PROPOSAL REQUEST

PROJECT:	LXT Hangar 2 Eastside Development	PROPOSAL NO:	11
OWNER:	City of Lee's Summit	DATE OF ISSUANCE:	04/11/25
TO:	Fogel-Anderson Construction 1212 E. 8th Street Kansas City, MO. 64106	ARCHITECT:	Wellner Architects, Inc. 1627 Main Street, #100 Kansas City, MO 64108
COPY:	File		
CONTRACT FOR:	General Construction	ARCHITECT'S PROJECT:	2219
CONTRACT DATE:

Item 1. SHEET A610 FINISH SCHEDULE:

E201

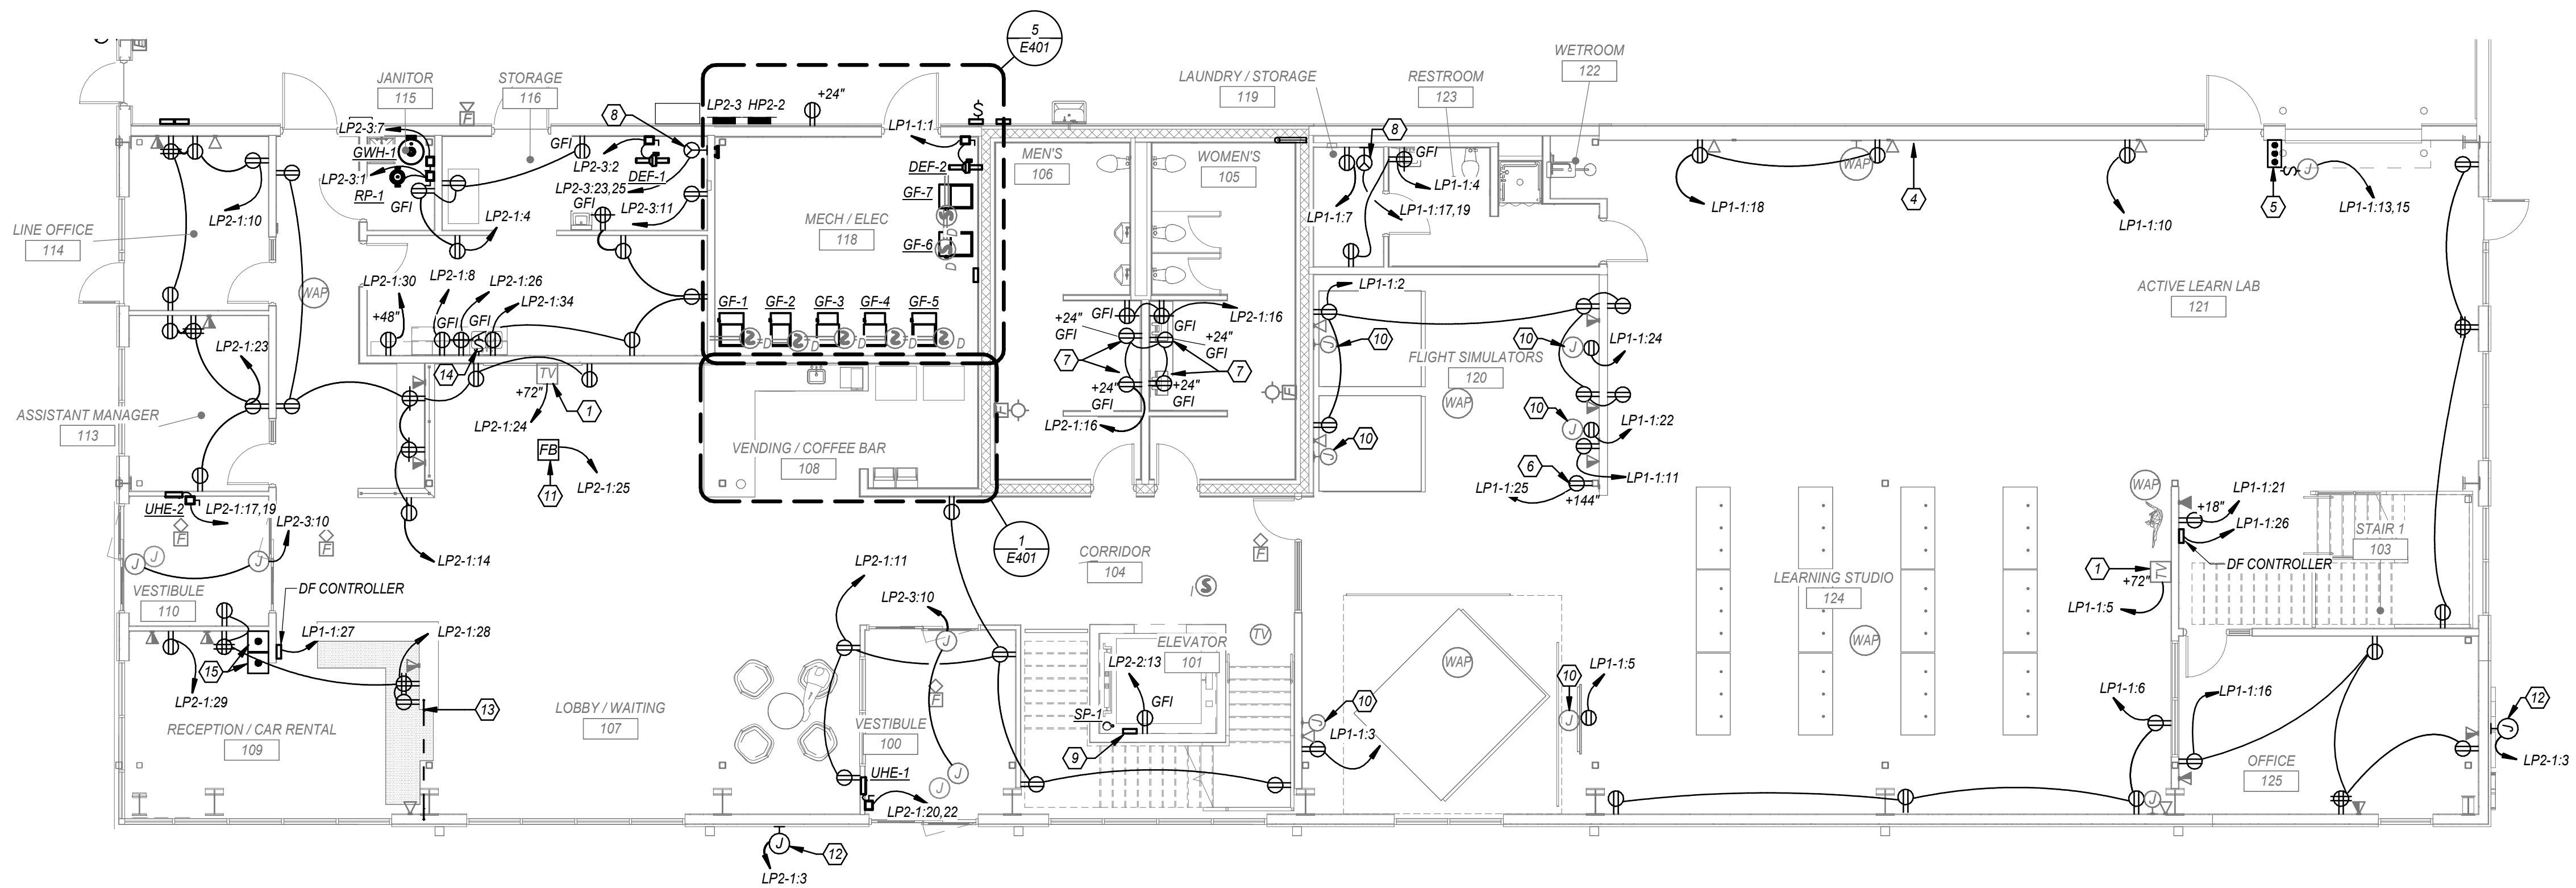
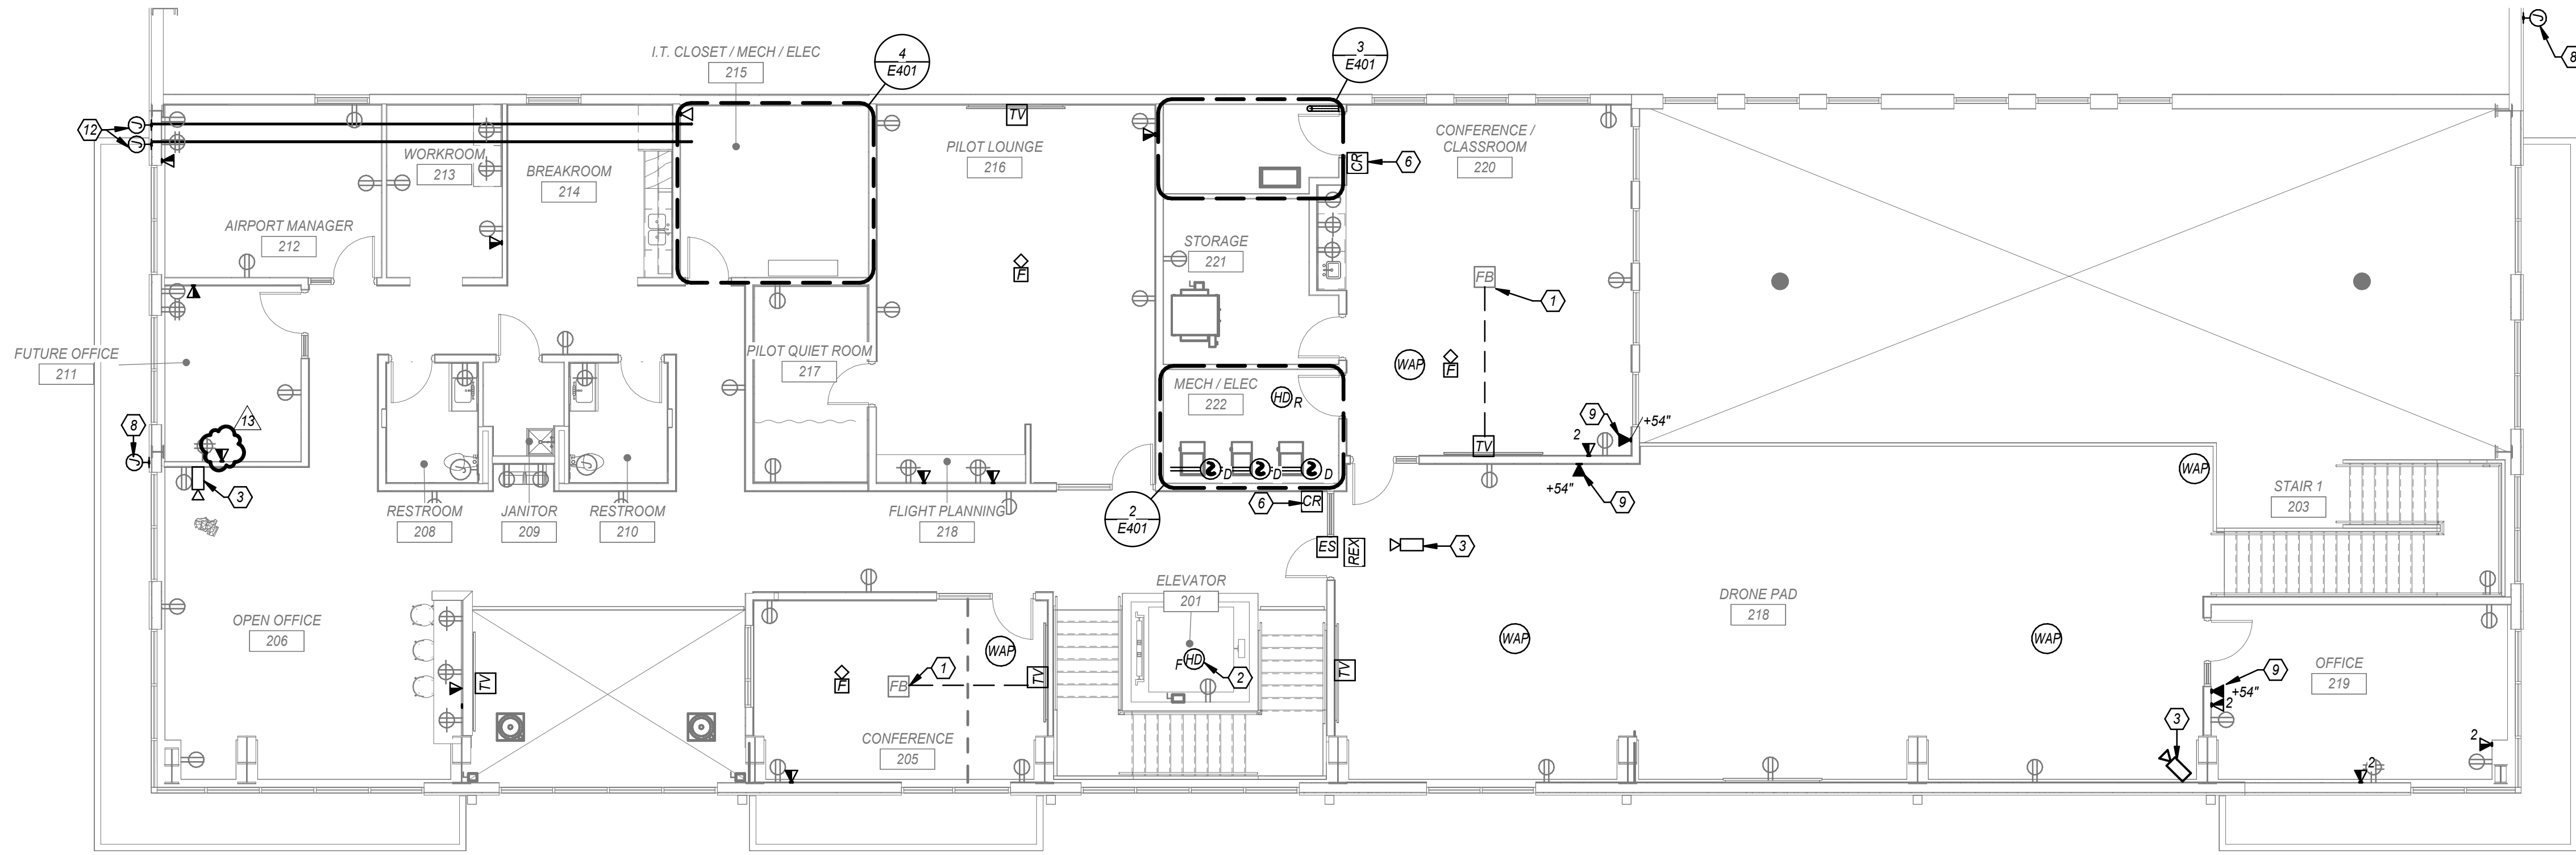
Item 3. SHEET E201 POWER FLOOR PLANS:

POWER SECOND FLOOR PLAN 2 FUTURE OFFICE rm 211 **Add** four plex receptacle.

POWER SECOND FLOOR PLAN 2 PILOT LOUNGE rm 216 **Add** duplex receptacle.

E301

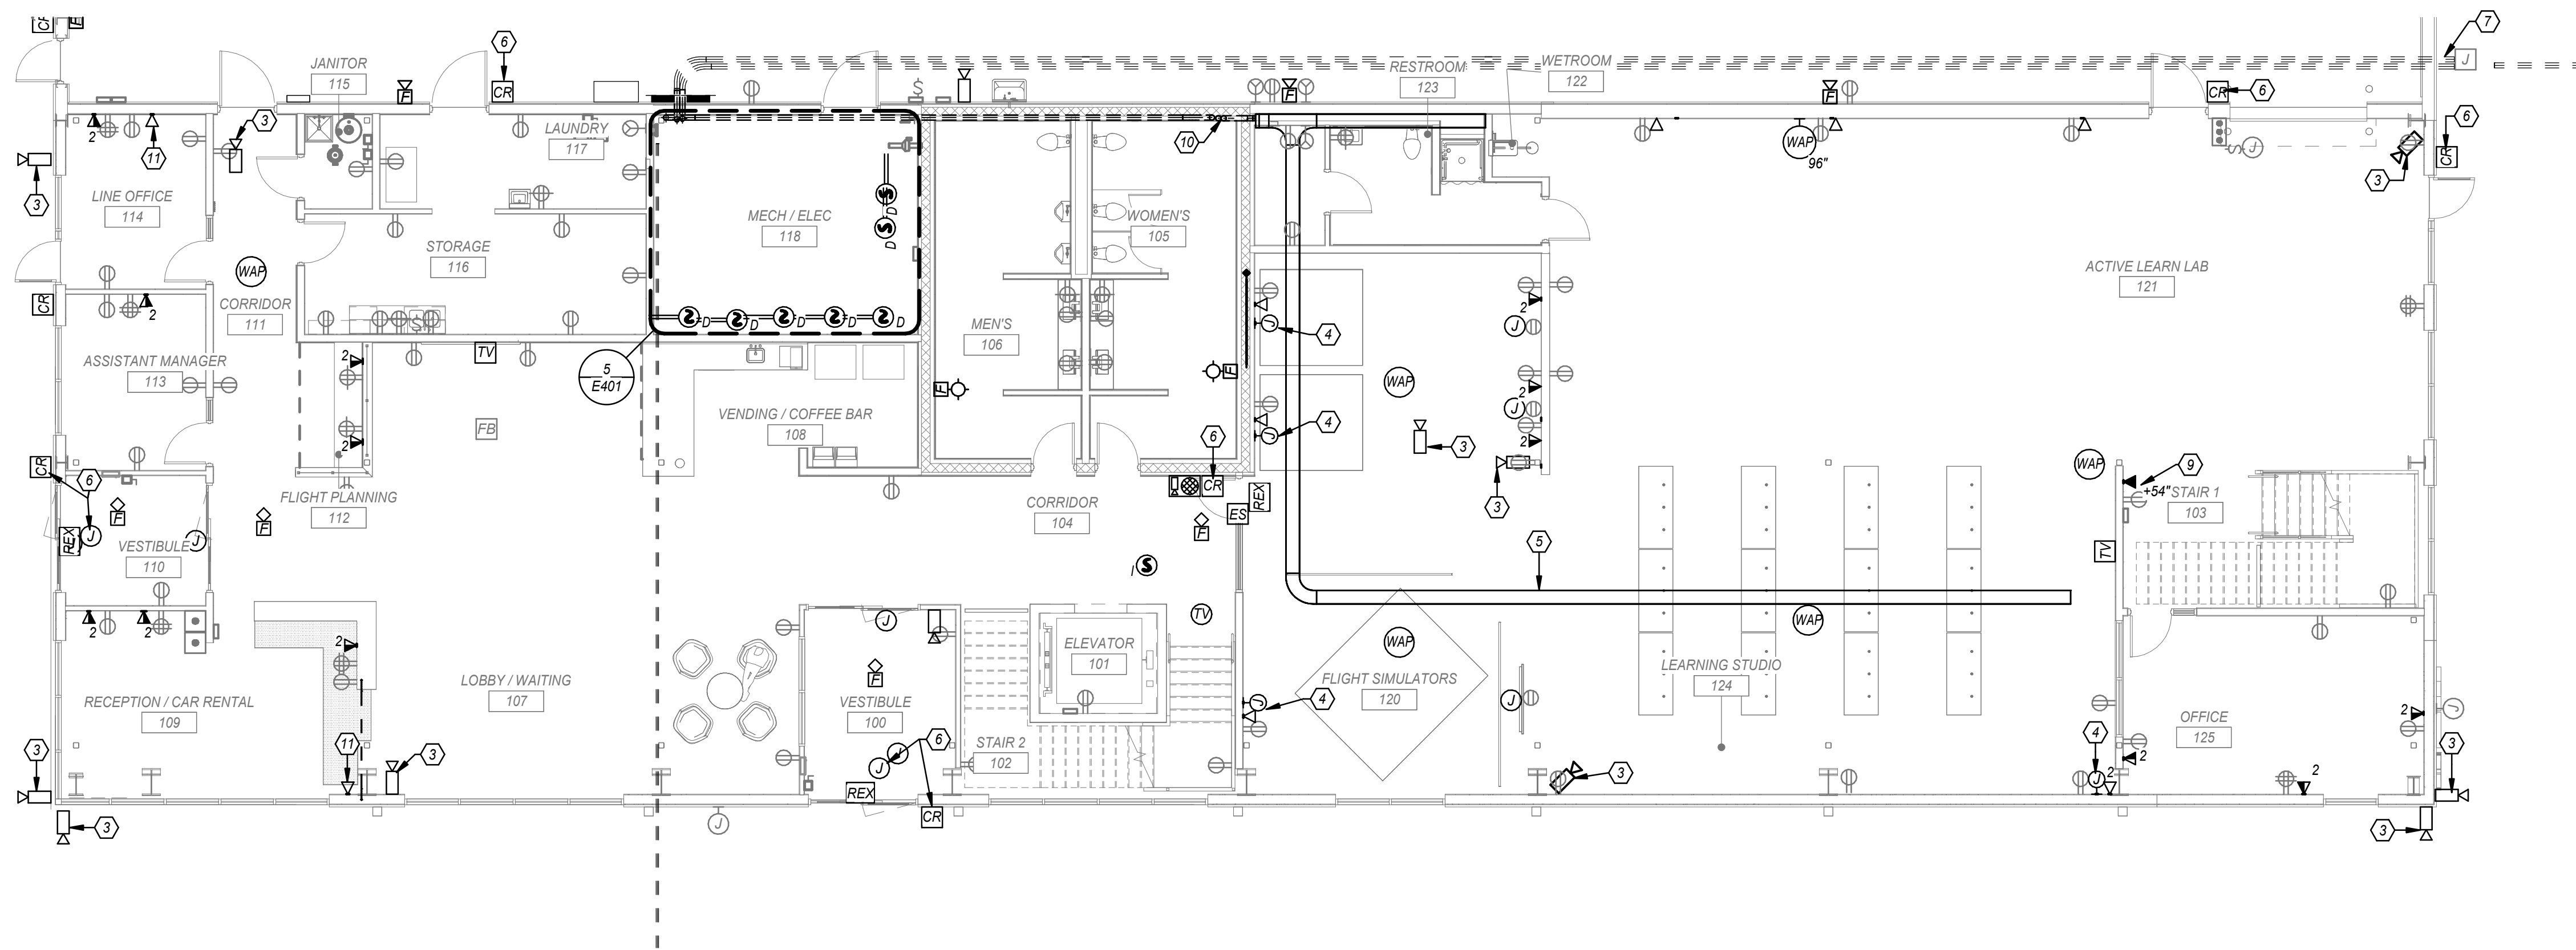
Item 4. SHEET E301 SYSTEM FLOOR PLANS:

SYSTEM SECOND FLOOR PLAN 2 FUTURE OFFICE rm 211 **Add** data/phone outlet.
